D/DRC Case

907 Senate Street

DESIGN/DEVELOPMENT REVIEW COMMISSION
DESIGN REVIEW DISTRICT
HISTORIC AGENDA
EVALUATION SHEET
Case # 1

NATURE OF REQUEST: Request Certificate of Design Approval for exterior changes

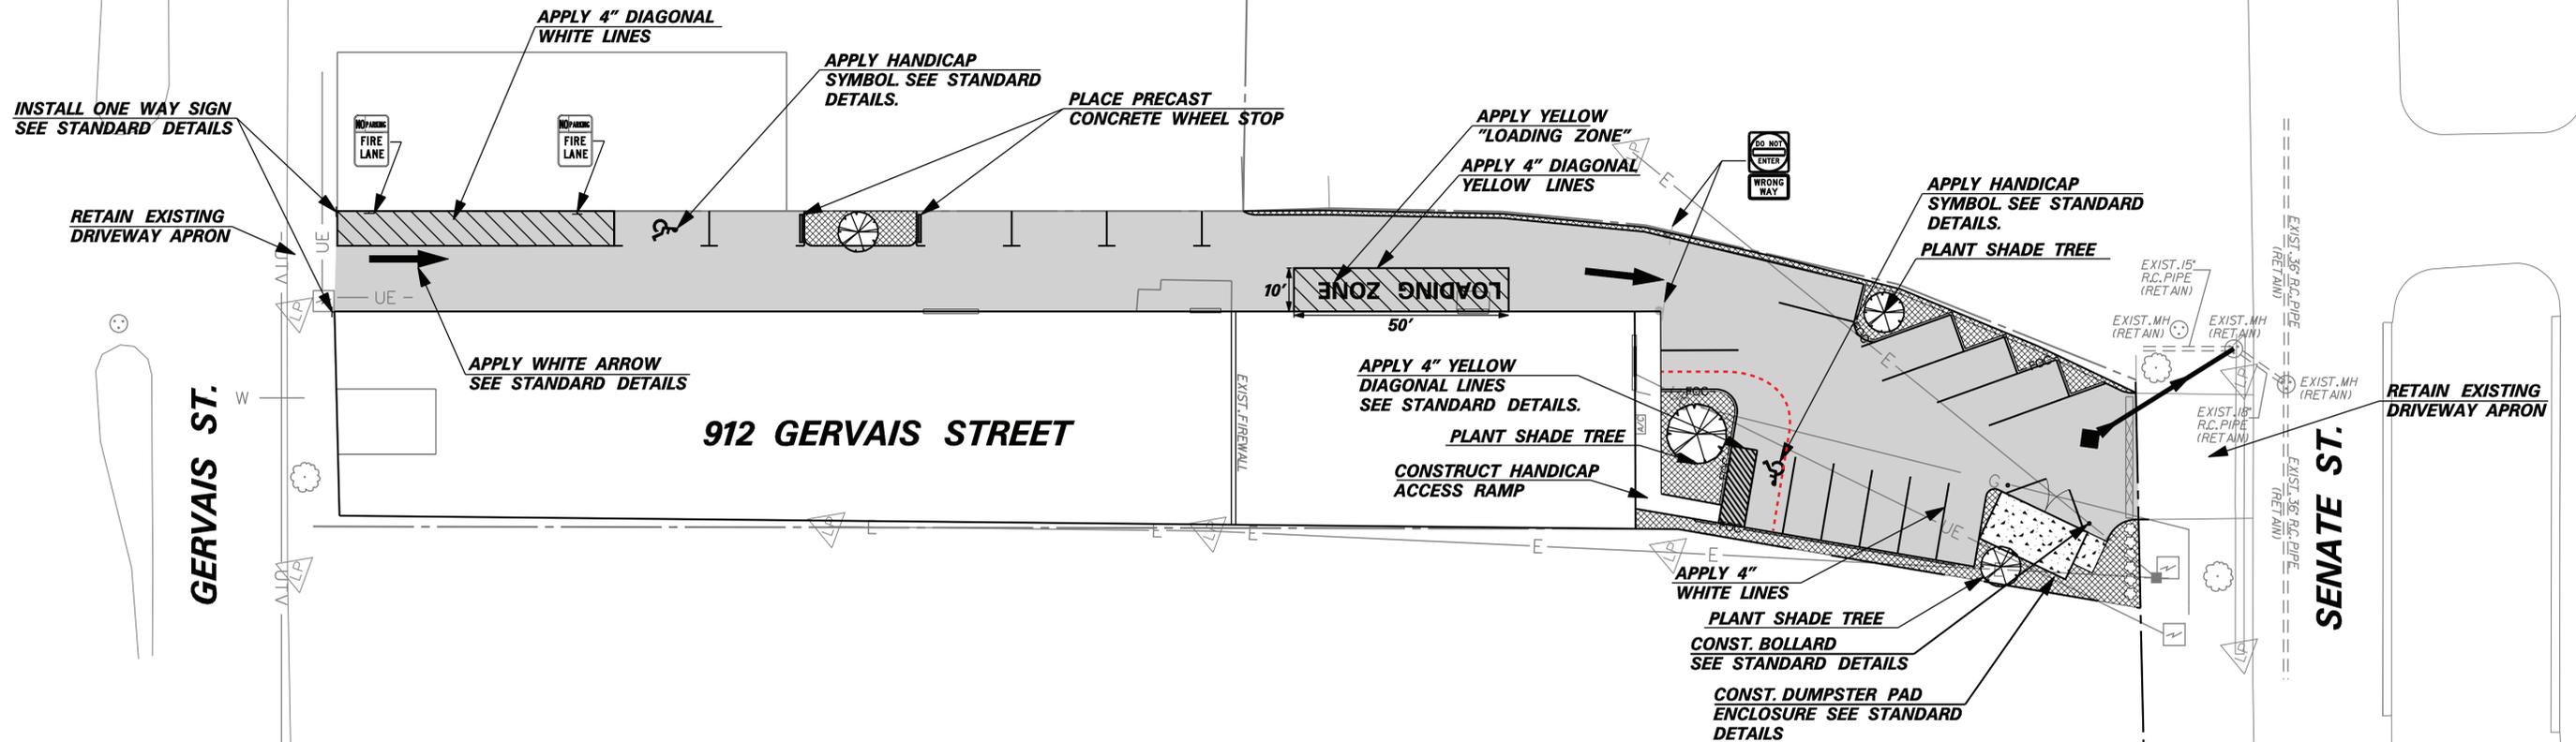
Staff is evaluating whether a tree can be placed to the left of the driveway, due to the placement of utilities. If it can be, then it should be planted. Per this guideline, a hedge must also be planted at the left side of the parcel on Senate Street.

A hedge, with a minimum of 36-42” in height should be installed to the left of the driveway; there are various utilities which will need to be worked around.

As there is an existing hedge along the right side of the streetfront of the parcel, staff would recommend installing another hedge to the left of the curb cut. There are various utilities there that will have to be accommodated.

REV. NO.	BY	DATE	DESCRIPTION OF REVISION																	
TOPO.		DATE																		
DWG.		DATE																		
R/W		DATE																		
			<p>PLAN SCALE 1" = 20'</p>	<p>DWG. NO. C-2A</p>

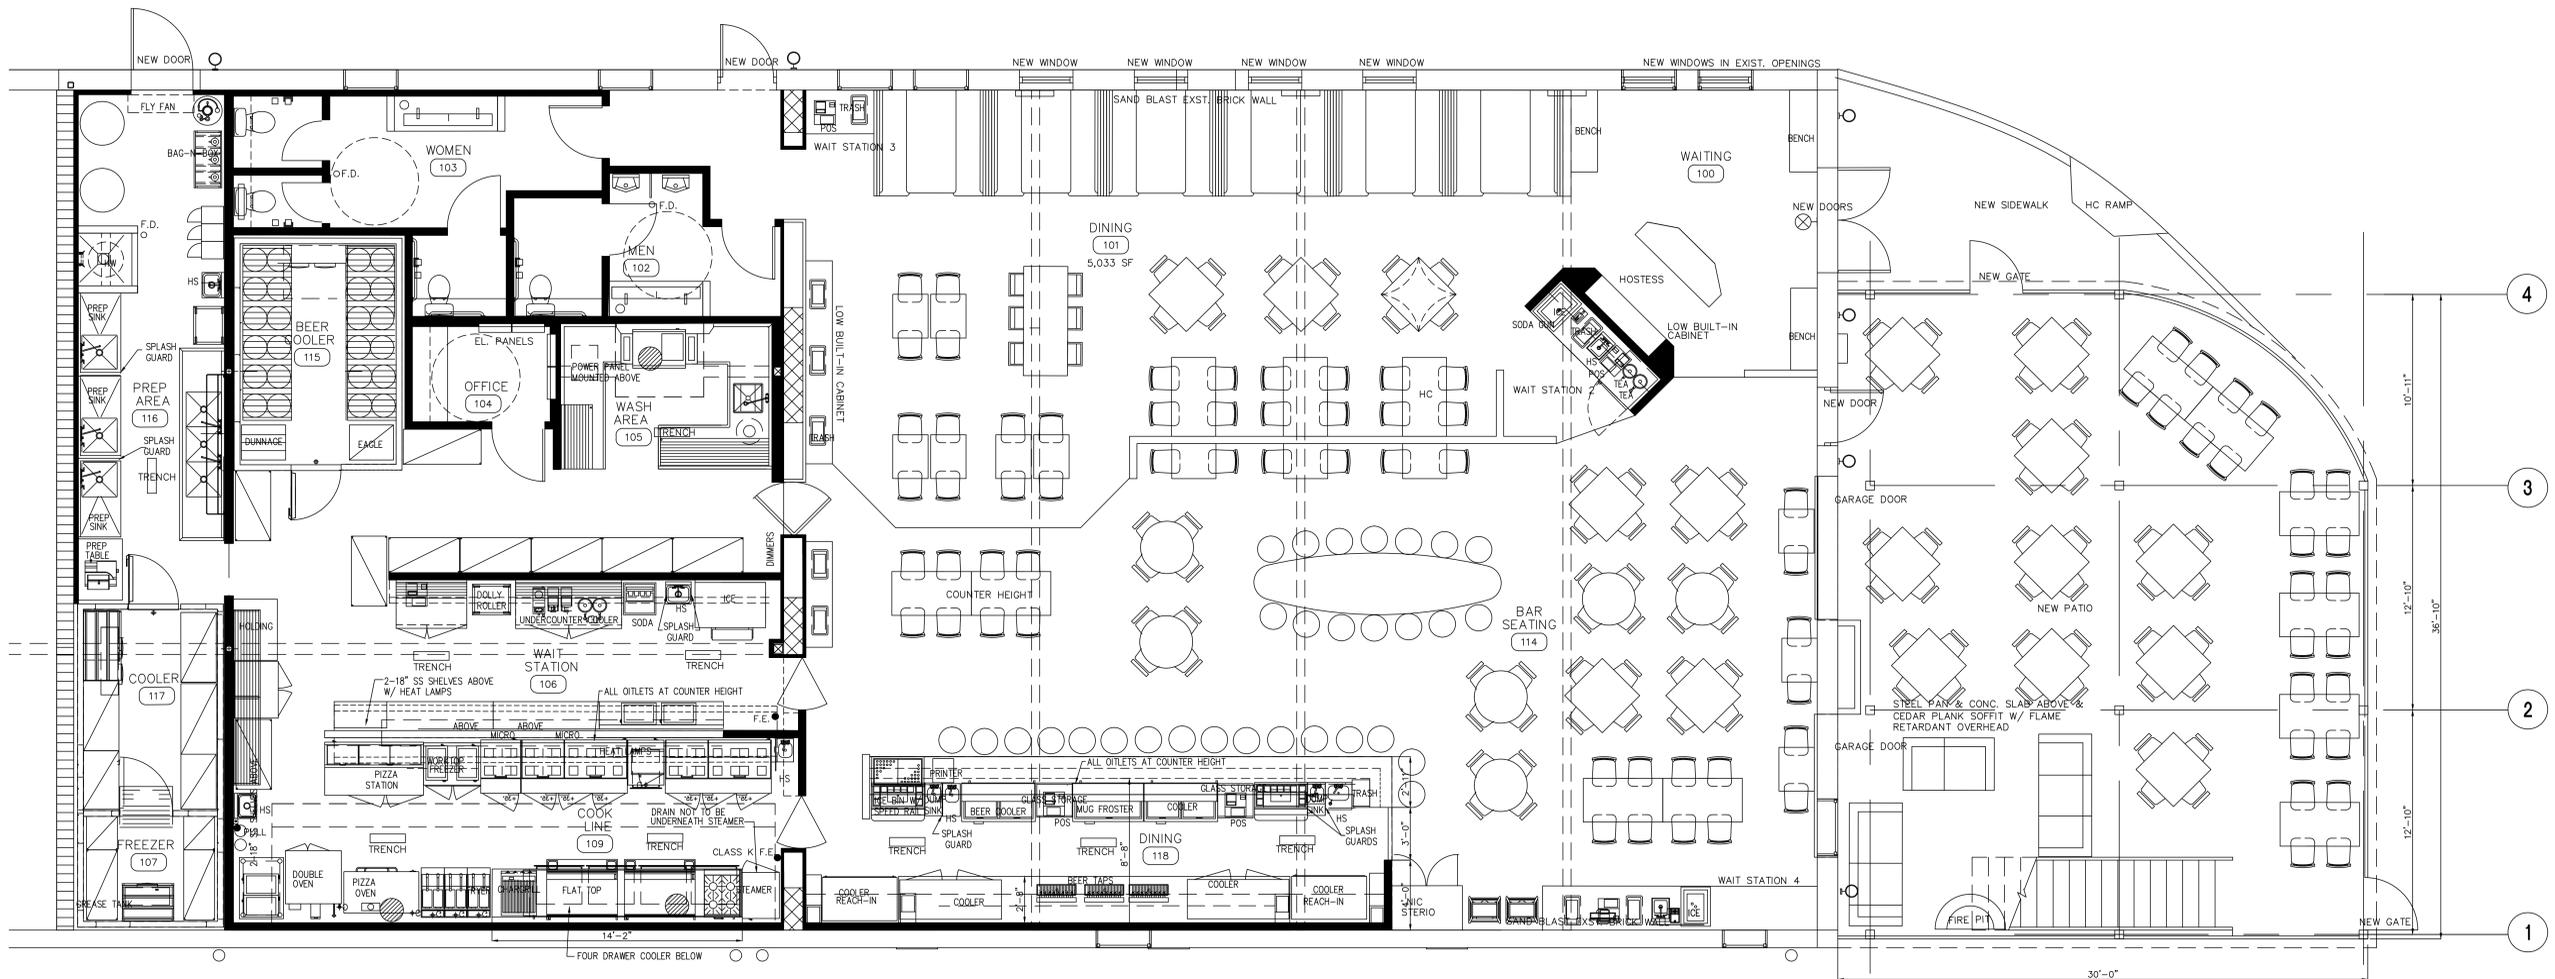
The area devoted to parking in the back of the lot is small enough that landscape islands will not be necessary.

Per the City ordinance, for existing buildings with newly configured parking lots, shade trees must be 60' apart. The applicants will have to ensure that this requirement is met in the back parking lot.

1 SOUTH ELEVATION
A6.0 SCALE: 1/4" = 1'-0"

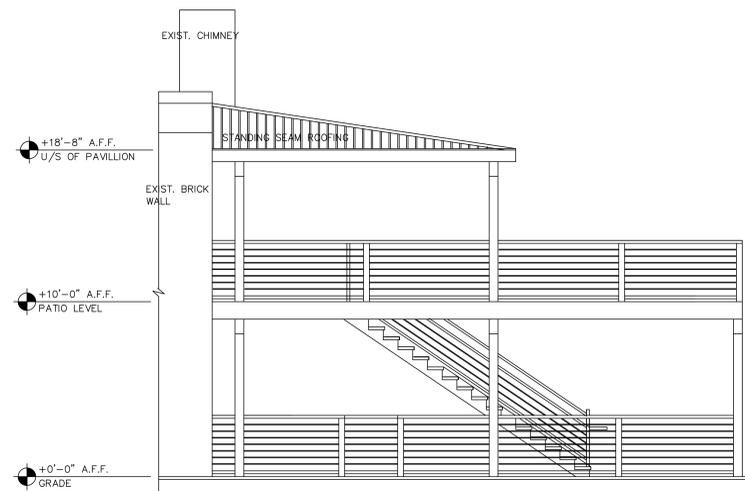
The large loading door to the right of the building will be converted to a set of double aluminum doors that will serve as the entry to the restaurant. This will require a small amount of infill since these doors will be @ 1' smaller than the current opening. The owners have salvaged brick which they will use for the infill. Mortar for the brick infill should match existing mortar in color and profile. A metal canopy over the door is proposed but details have yet to be worked out. Wall signage is planned above the canopy as well as a projecting sign for the alley but this can be worked out at staff level as the project progresses.

Immediately to the left of the new entry is a two story outdoor dining area. This will be approximately 1,080 s.f. per floor and will require the removal of the extant curb as the proposed porch extends past it. The small newly-planted tree in the back lawn will have to be removed or re-located and a parking space will be lost. The porch itself will be a black metal structure with concrete slab flooring on both bottom and upper stories. Soffits will be

tongue in groove cedar with a clear protective stain. Metal support posts will be a maximum of 6"x6". Originally vertical pickets were envisioned for the railing, but horizontal cables, as pictured, provide a less residential feel and are visually less intrusive. The porch curves at its right side; staff would recommend either a simple 90 degree angle instead to keep the lines consistent with the building's simple lines.

The roofline of the building steps down gently as it moves to the left and has a nice terra cotta coping. The roof of the new porch as originally proposed would have been a shed style, standing seam metal roof with a low pitch which would align horizontally with the highest part of the roof on the right but would require building up the roof support on the left to maintain a consistent horizontal line. However, a porch roof which would allow the building's original roofline to read is desirable. The architect accordingly tried a low pitched half-hip roof (shown). This does not require building up the original roofline but doesn't complement the simple roofline immediately above and is not typical of the district. Staff believes that a very low-pitched roof or even no roof would be preferable in this instance.

Two new garage style doors and single entry door are proposed at the first floor, allowing access between the indoors and outside. These openings reference the loading door and the use of the back of the structure and again, since this is not a significant elevation, these openings are permissible. If the DDRC permits, staff is happy to work out the details of these doors with the architect.

- A flat or low-pitched or no porch roof with details approved by staff;
- Roof cladding details to be approved by staff
- The balustrade to maintain a right angle rather than a curved angle on the corner;
- Specifications regarding all doors and windows to come to staff for review;
- Signage and entry canopy details to come to staff for review
- A new landscape plan will need to be submitted to meet City ordinance and design district guidelines for the parcel
- All details deferred to Staff
